ADDENDUM NUMBER: One (1)

TITLE: Imeson Substation T2 Addition

JEA SOLICITATION NUMBER: 1411877047

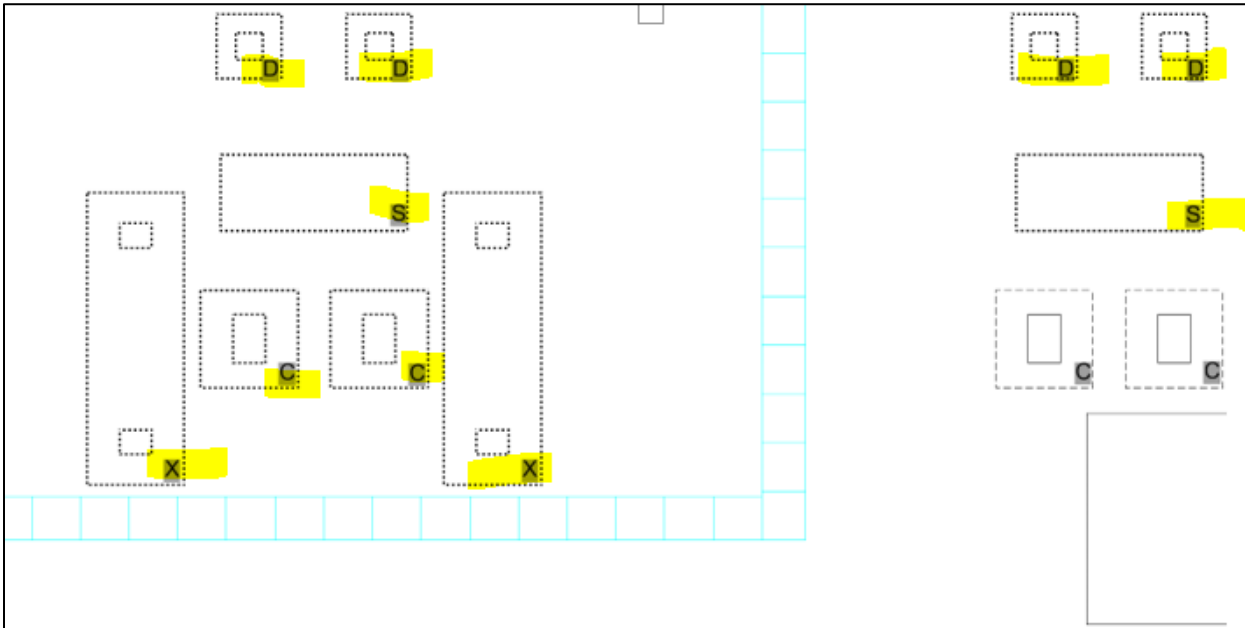
3. **Question:** Manhole 10'x16'x7' Vault Precast Concrete will be provided by JEA or by Contractor?

**Answer:** Contractor will NOT furnish and will NOT install any manholes on this bid. All manholes have already been installed.
